AMENDMENT OF SOLICITATION/MODIFICATION OF CONTRACT

2. AMENDMENT/MODIFICATION NUMBER	3. EFFECTIVE DATE	4. REQUISITION/PURCHASE REQUISITION NUMBER	5. PROJECT NUMBER *(If applicable)*
0001	09 JUN 2026		ED 22-050

W912P826BA003
Freshwater Bayou Waterway, Freshwater Bayou Lock, New Shops Building, Vermilion Parish, Louisiana

SHEET IDENTIFICATION Nos. C-103, S-001, S-101, S-201, and S-301. Delete these drawings in their entirety and substitute the attached revised drawings SHEET IDENTIFICATION Nos. C-103, S-001, S-101, S-201, and S-301.

SHEET ID
S-001

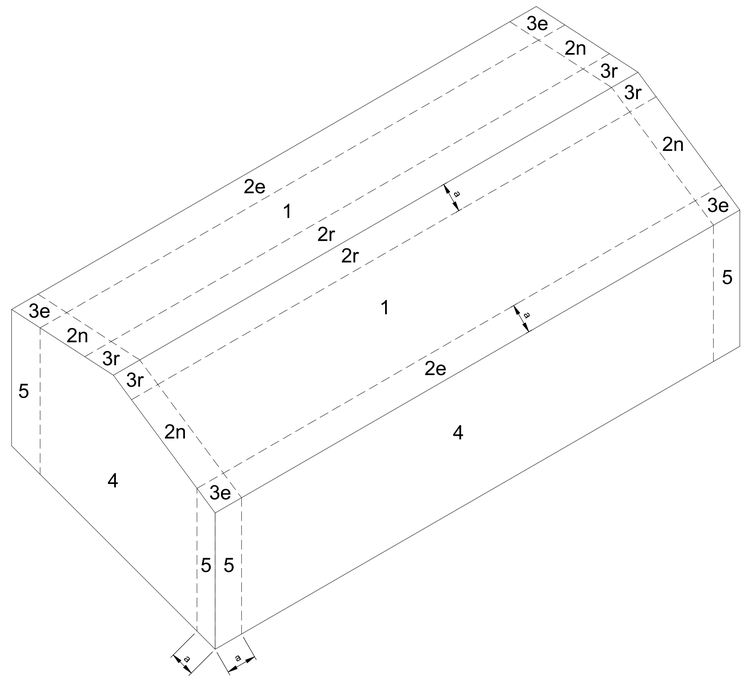
The building is considered to be "Partially Open".

MARK	DESCRIPTION	DATE
1	CLARIFIED PRESSURE COEFFICIENT	04/2026

A. RISK CATEGORY: IV
   B. BASIC WIND SPEED: 164 MPH
   C. ALLOWABLE STRESS DESIGN WIND SPEED VASD = 127 MPH
   D. EXPOSURE CATEGORY: D
   E. INTERNAL PRESSURE COEFFICIENT: ±0.18 (PARTIALLY OPEN)

S-101

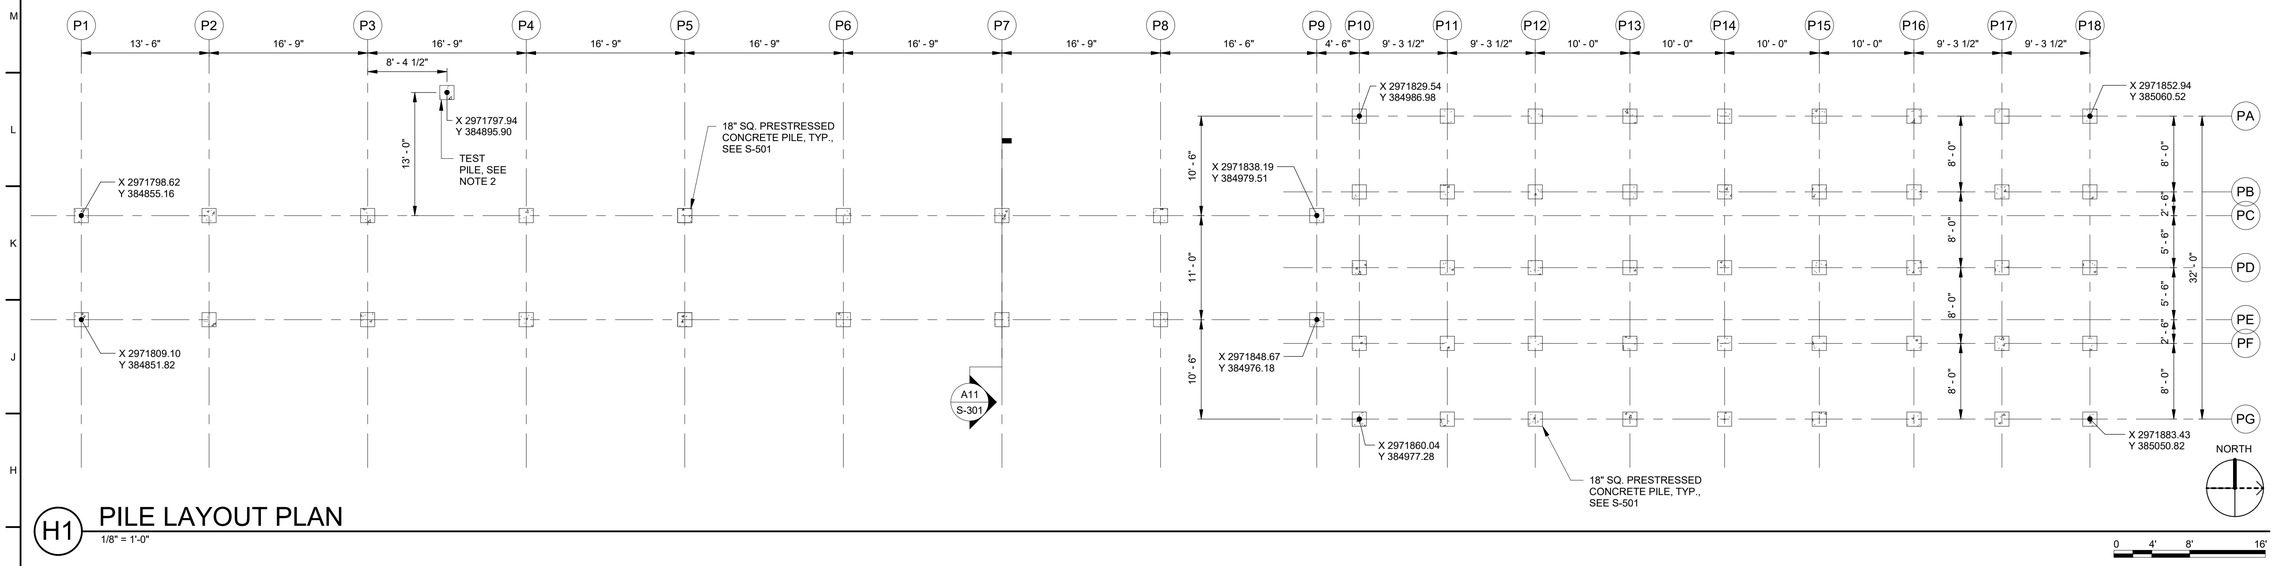
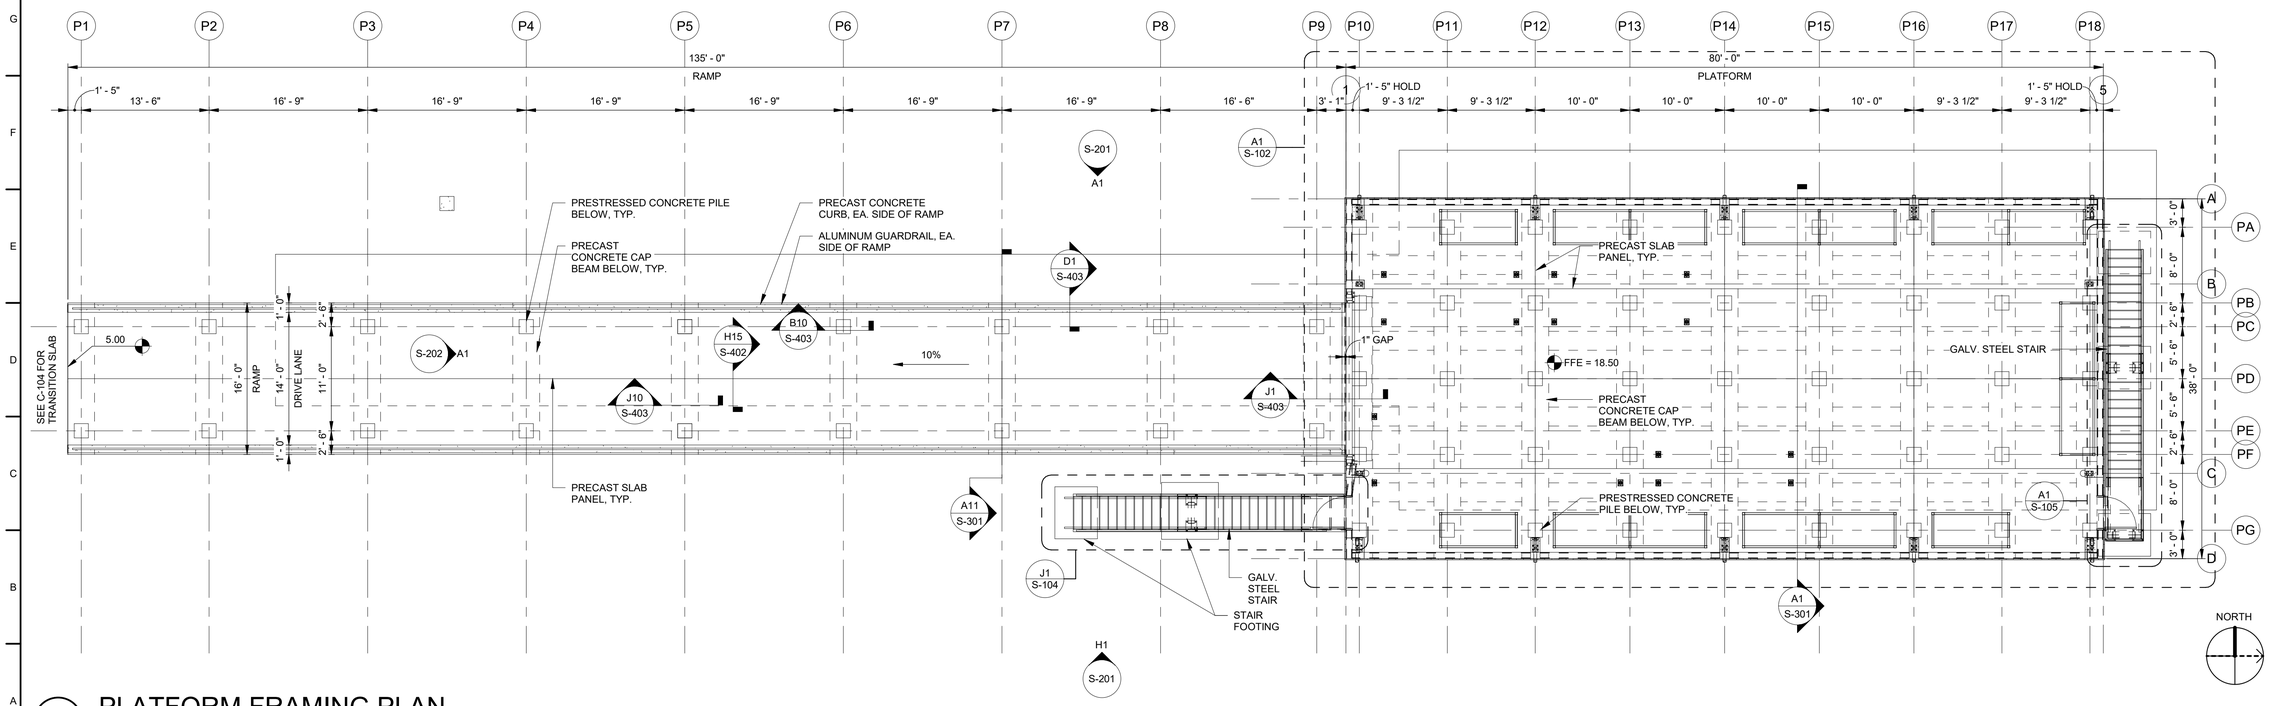
25. Dwg D1 S403 – Confirm the curb is to be precast and not cast in place. If so, another reason is not to have railing anchors pre-installed.
    Reference curb notes A1/S-101 and A11/S-301.

SHEET ID
S-201

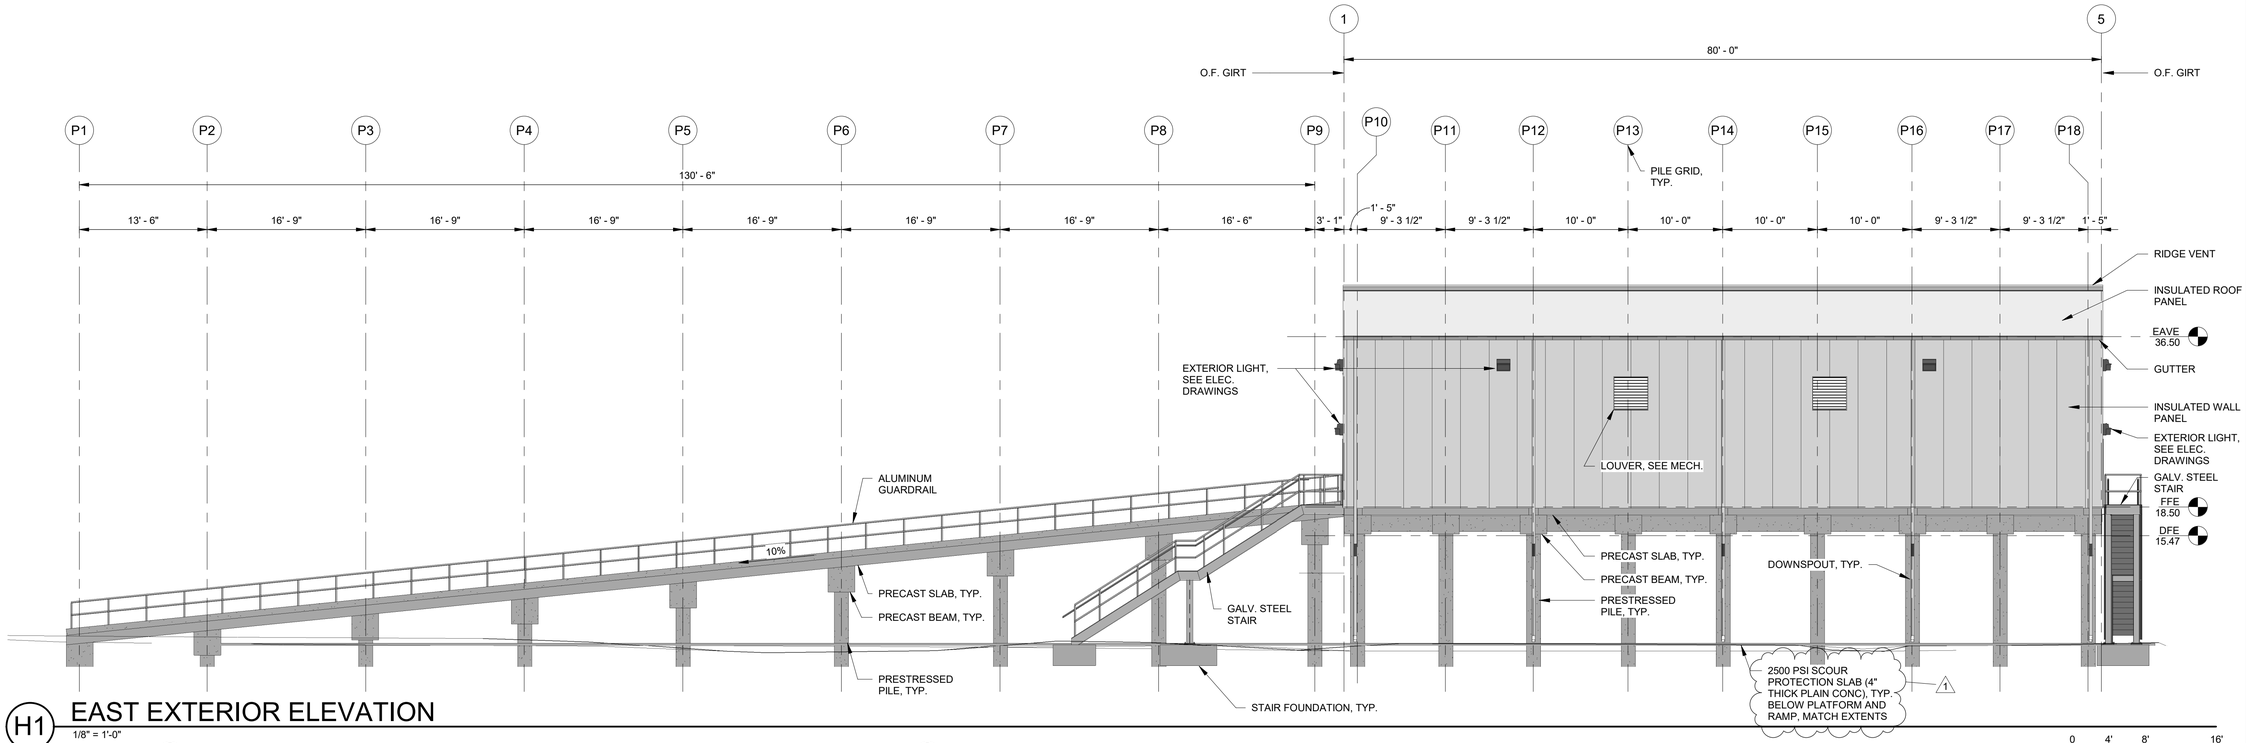
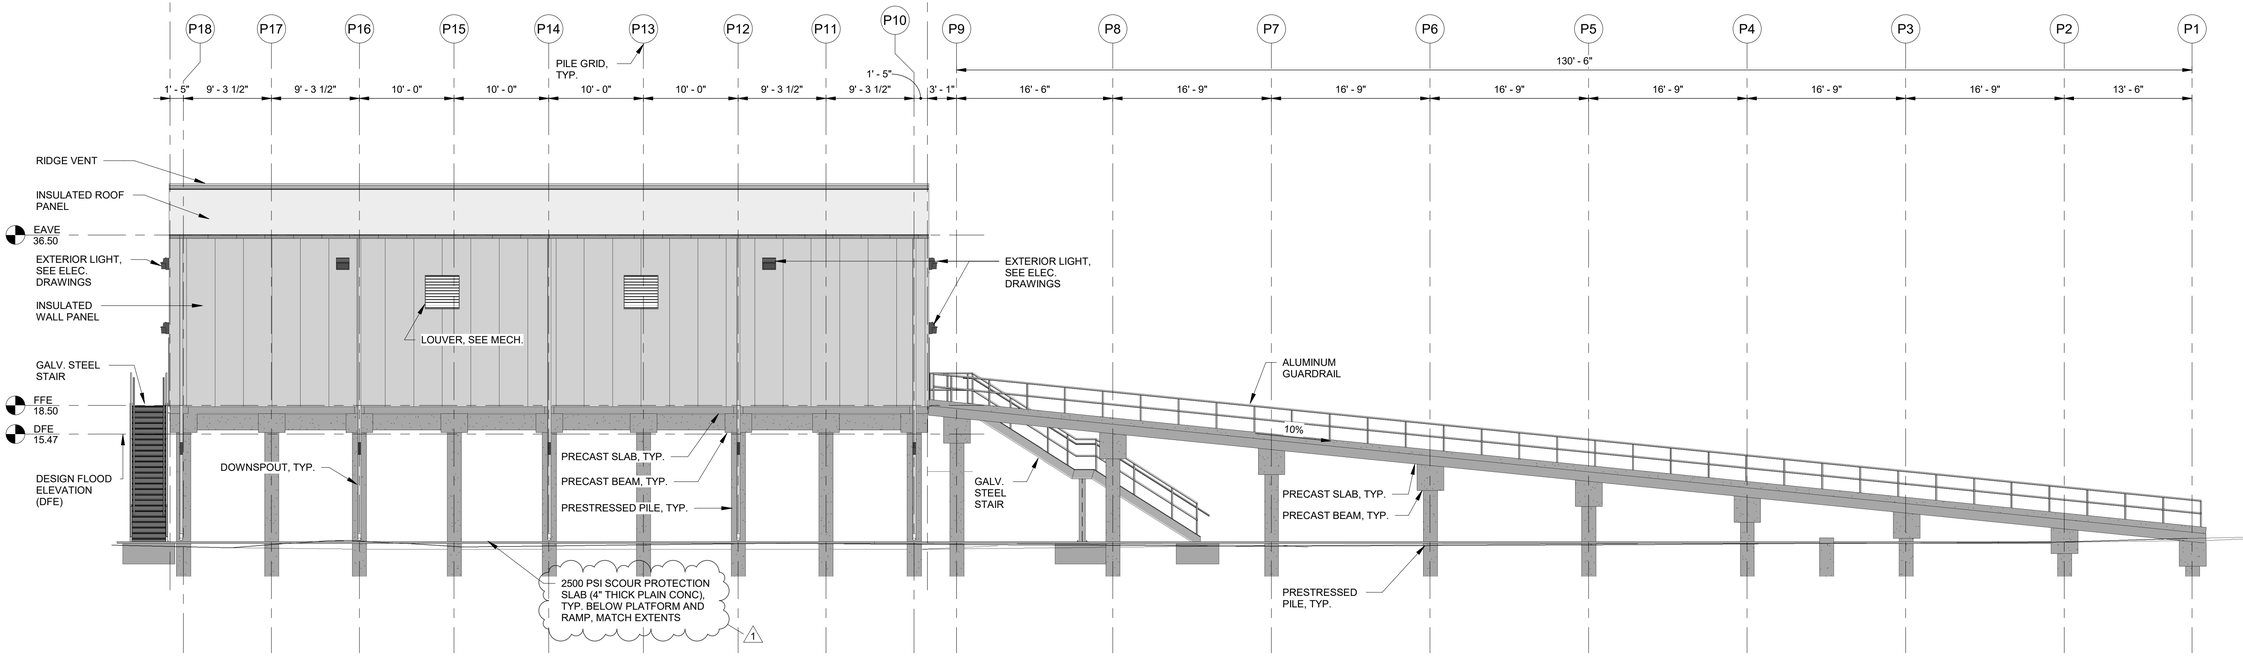
14. Please confirm the 4" thick concrete scour slab is to be placed under the ramp as well.
    See Sheet S-201.

15. Confirm the scour protection slab is to have wire reinforcement. Some areas do not allow the use of wire reinforcement for such pads in hurricane zones.
    The scour protection shall be 4-inch thick concrete with no wire reinforcement.
